Board of Health

MEMORANDUM

TO: Sherborn Zoning Board of Appeals, ZBA
FROM: Sherborn Board of Health, BoH
DATE: February 26, 2024
RE: Farm Road Homes 40B – Compendium of BoH Determinations, Comments, and Recommendations Regarding Public Health Requirements

Multi-Well PWS Layout
(for purposes of concept illustration only)

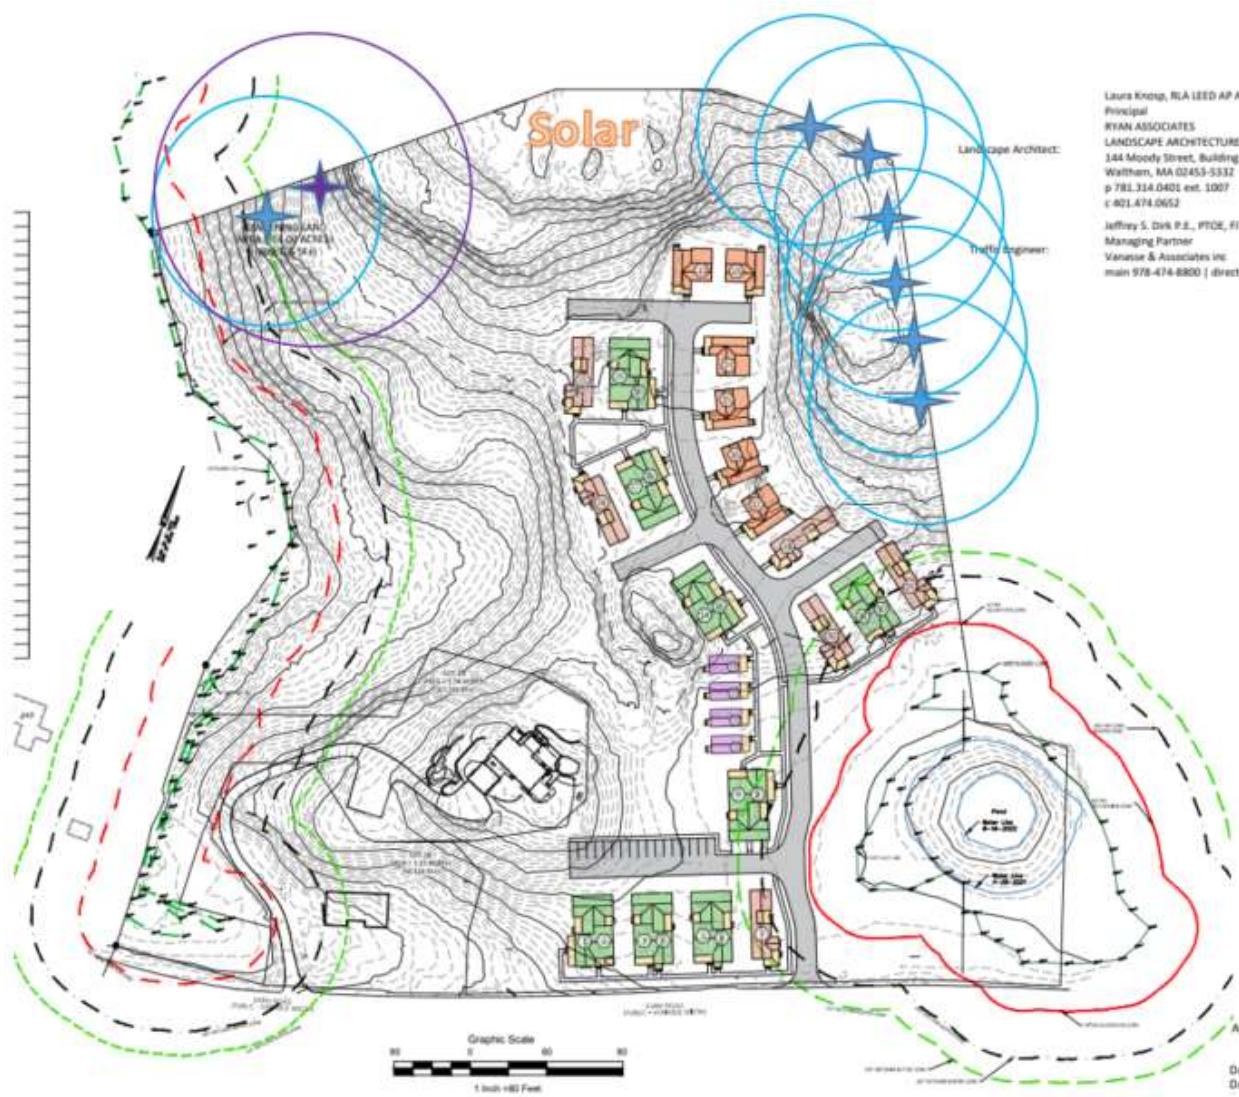
A rough illustration of a multiple-well PWS layout at the Farm Road site is presented below. It is not proposed as a required or even recommended layout. Instead, it merely demonstrates that alternative layouts may be possible.

Note that no attempt was made to alter currently proposed site plan features and thus the layout example works around them. At this stage of the project there is the ability to vary site plans significantly to accommodate alternative options, given that there is no new infrastructure yet.

Also note that having the Zone I's (the protective circles around each well) extend onto adjacent Town conservation land would require a formal agreement with the Town for compliance with MassDEP requirements for protection of PWS integrity.

Wellheads (roughly 60 to 80 feet apart between adjacent wells; the adjacent blue and purple wellheads are intended to show mutually exclusive options)
	Zone I that can support supply volume that aligns with the minimum 125-foot protective radius
	Zone I with a 180-foot protective radius (i.e., can support a pumping rate in gpd equal to approximately 225% that of the 125' protective radius)
Solar	Location of a possible solar array
not to scale; based on an excerpt from a CLAWE plan, with only the elements noted above added; extensive site reconfiguration is not a BoH duty – this is a concept illustration
